**Independent Review
of**

**"Control Rod Insertion Following a Cold Leg LBLOCA,
D.C. Cook, Units 1 and 2"**

**D. A. Prelewicz
SCIENTECH, Inc.
Rockville, Maryland**

Boron Concentration vs Time

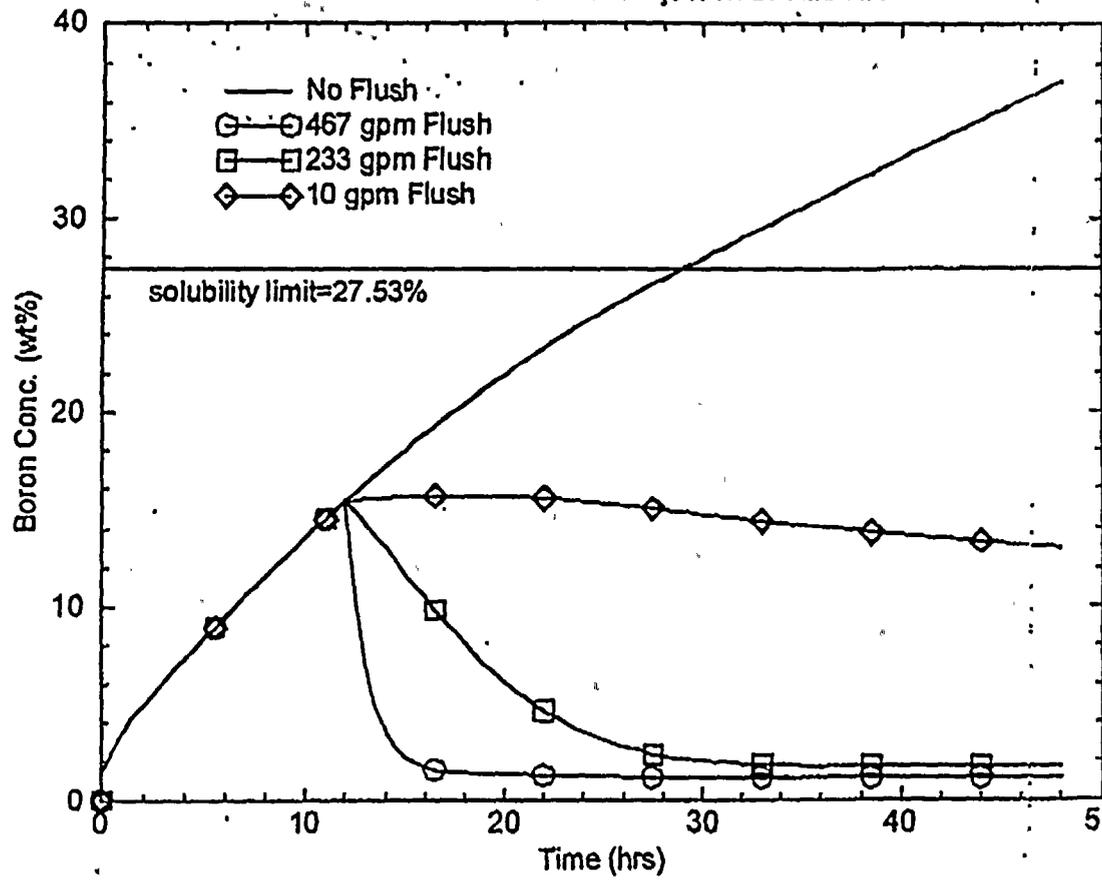
The attached figure presents the boron concentration versus time following a large break LOCA where reactor coolant system pressure remains near atmospheric pressure. The figure shows the boric acid content as a function of time with no flushing flow assumed and indicates that about 30 hours is available for the operators to initiate simultaneous injection. The solubility limit at 14.7 psia indicated in the figure is 27.53 wt%. Since the safety injection system provides sufficient flow to maintain the core covered with two-phase following reflood of the core, the rate at which the boron builds up is a function of the decay heat generation rate. Any additional injection into the cold side is merely spilled through the break. The equation solved to compute the boron concentration under these conditions is (please see the nomenclature section for identification of the symbols):

During the long term, the operators will need only a single high pressure pump to cool and control the boric acid build-up in the core. To show the effect of the net core or flushing flow, it was assumed that the operators switch to simultaneous injection at 12 hours into the event. The effect of several flushing flow rates is demonstrated in the attached figure where injection flows of 467, 233, and 10 gpm were assumed. These flushing flow rates maintain the long term boron concentrations at the values of 1.15, 1.73, and 12.9 wt% (i.e. 2001, 3017, and 22,680 ppm), respectively. Flushing flows associated with the 467 gpm injection rate therefore produce boron concentrations above the sump or source concentration at the time simultaneous injection is initiated. However, these analyses show that for a wide range of ECC injection rates, the concentration can be maintained well above the re-criticality condition of 1500ppm.

Comparison of the B&W Fuel Bundle with Westinghouse

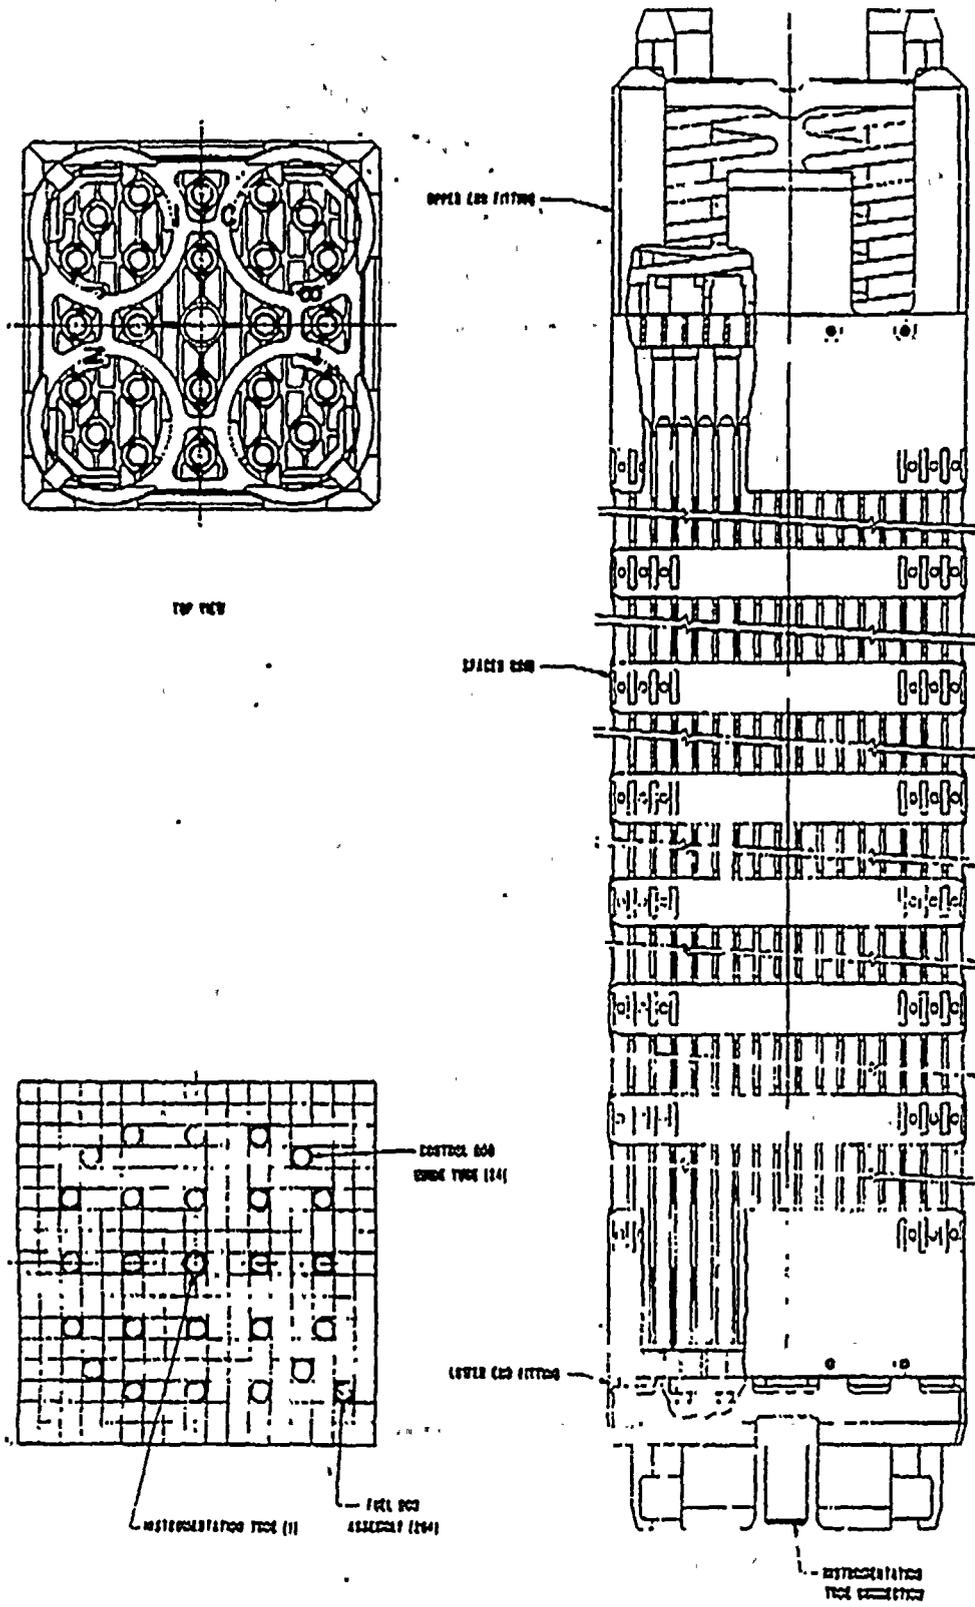
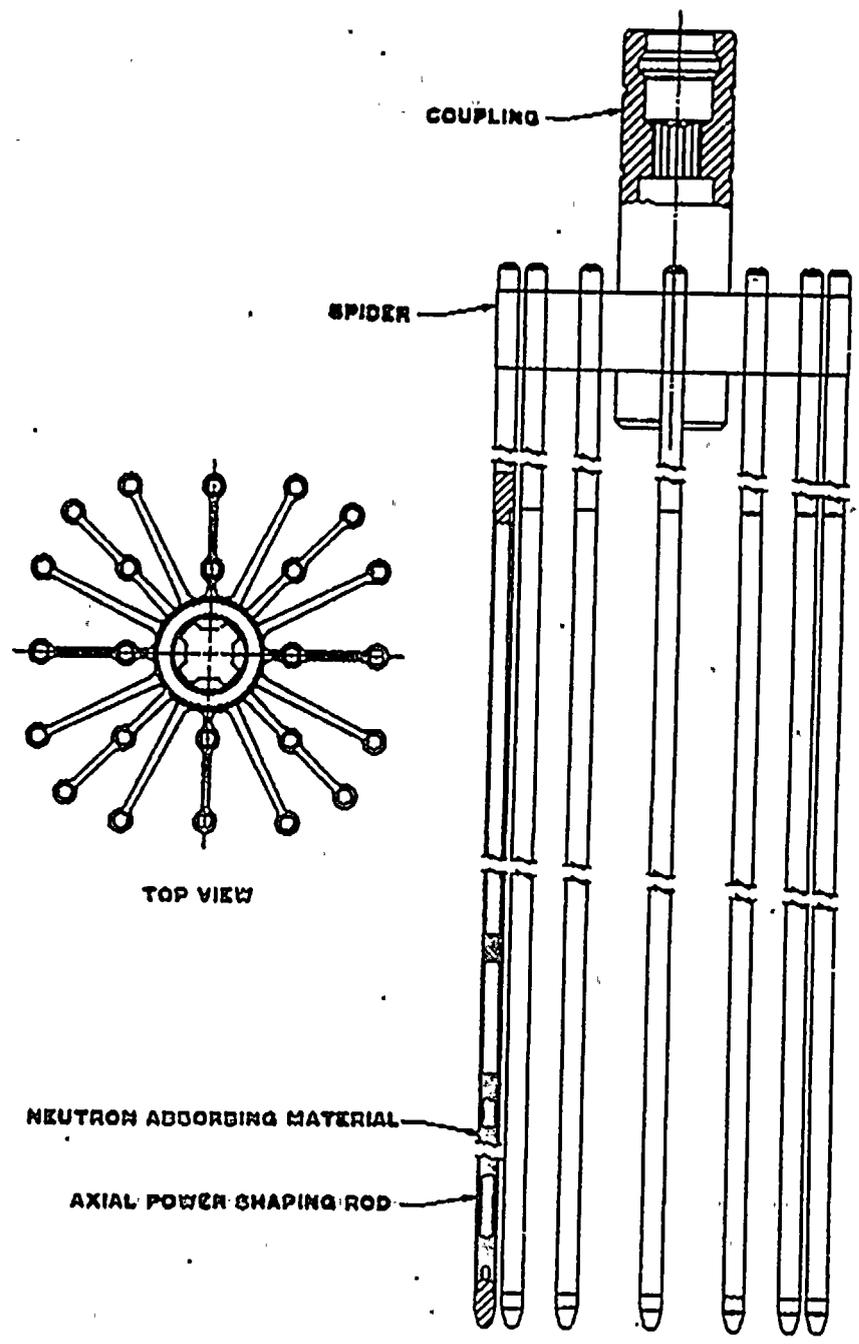
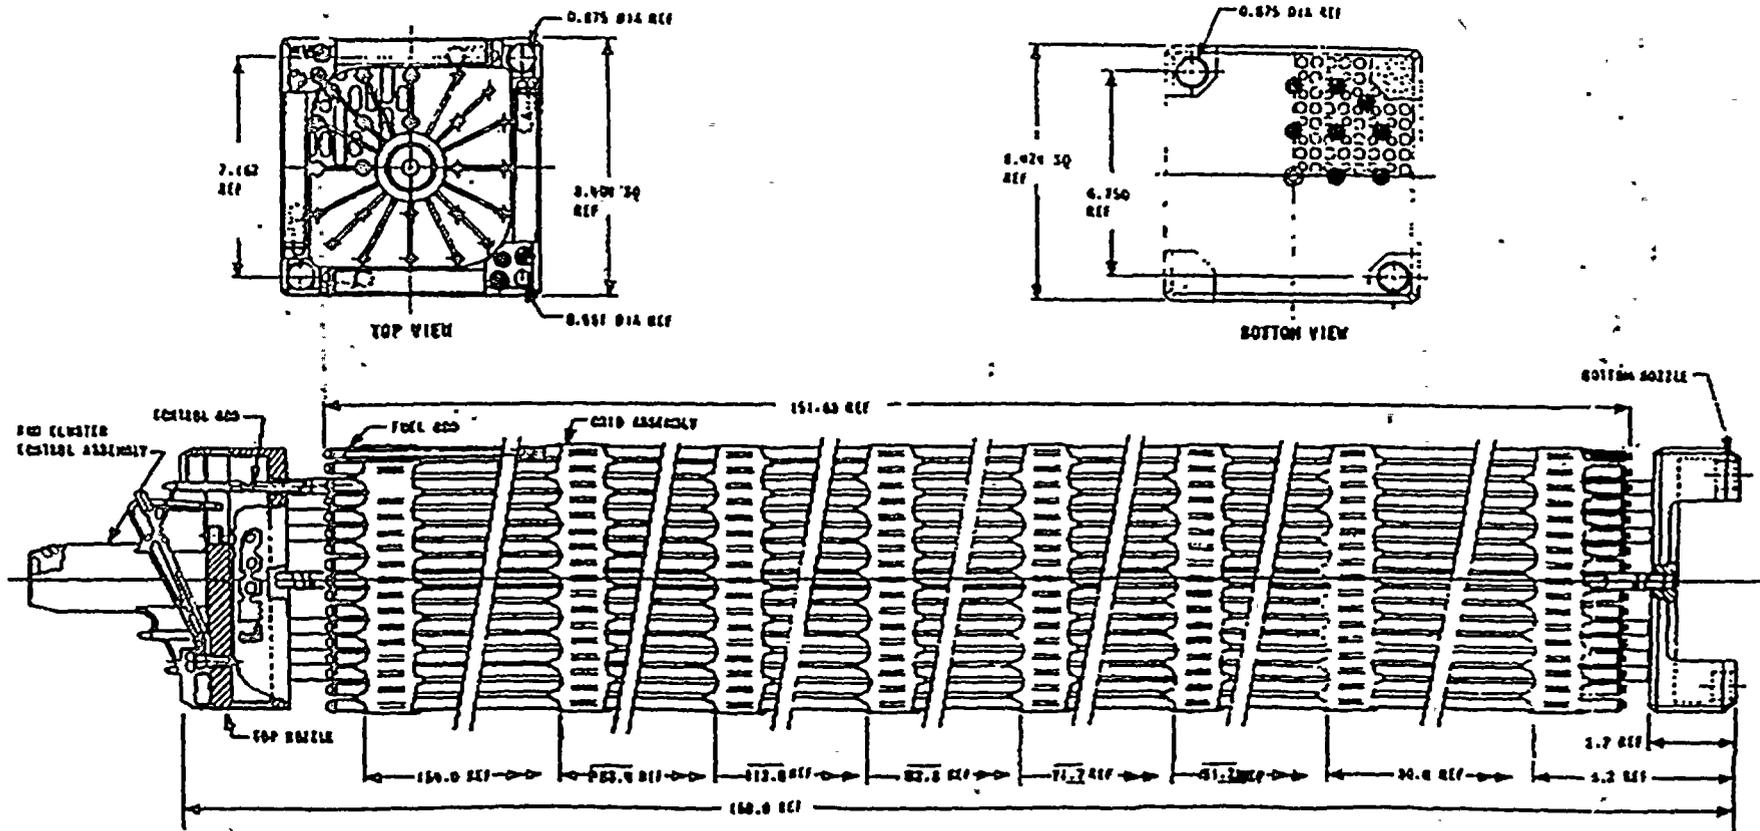
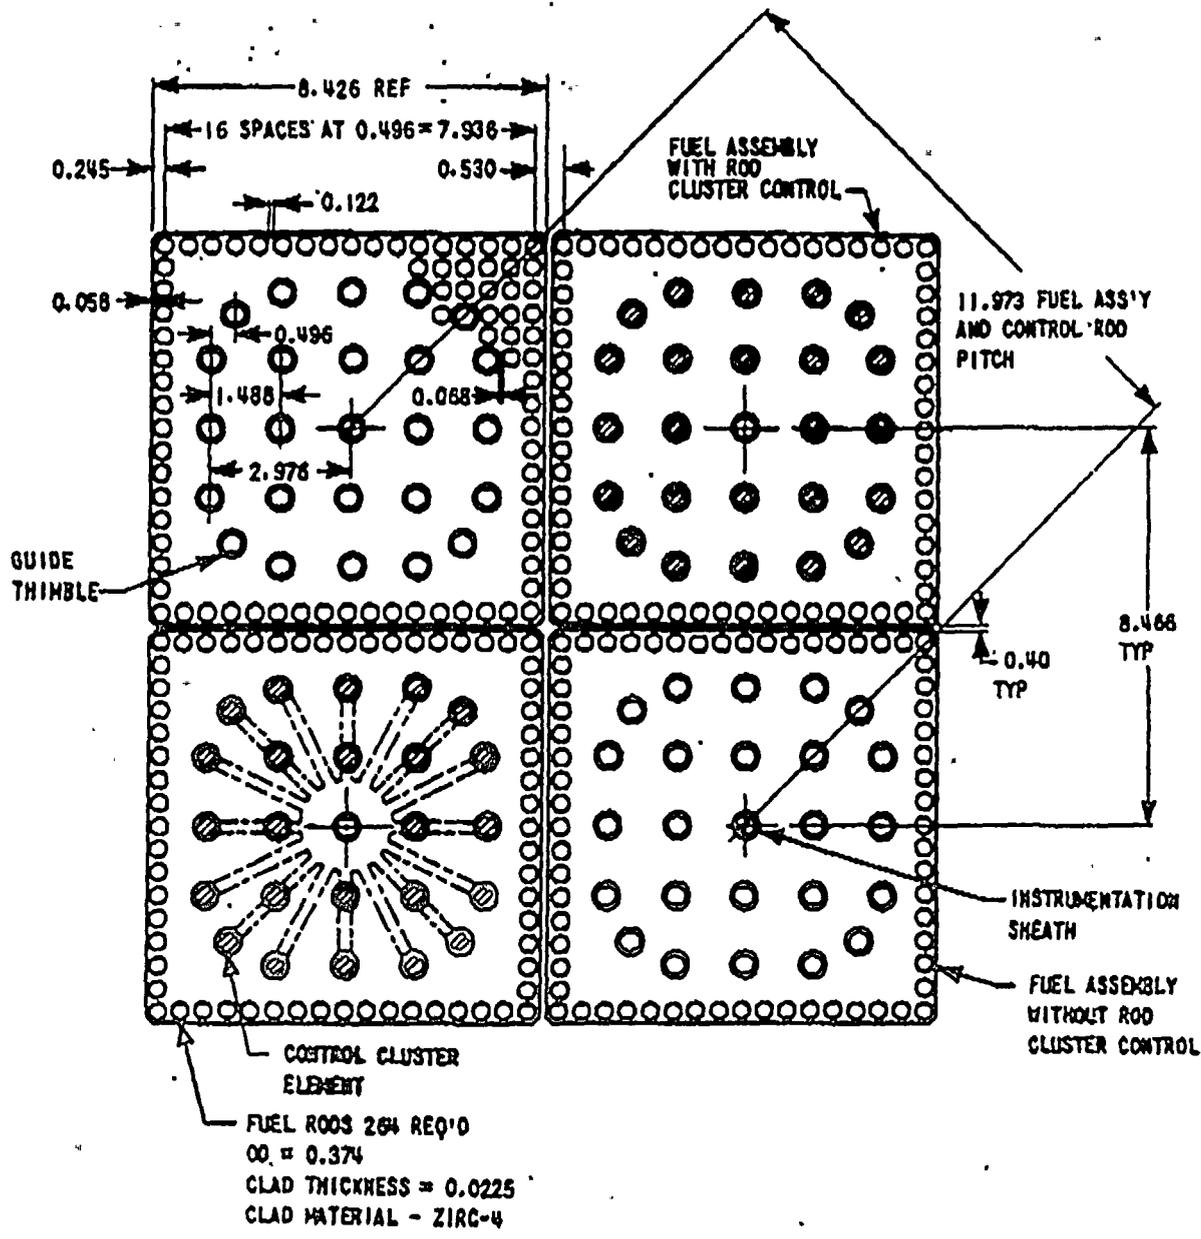
The B&W 17x17 fuel assembly is shown in Figs. 1 and 2 while the Westinghouse 17x17 fuel bundle is presented in Figs. 3 and 4. As demonstrated in the figures, both bundle designs are identical. Both bundle designs are 12 feet in length, contain eight spacer grids, and utilize a 24 finger control rod cluster. As such, the mechanical behavior of both bundles is expected to be similar so that the Westinghouse load evaluation can be concluded to also reflect the expected behavior of the B&W bundle design.
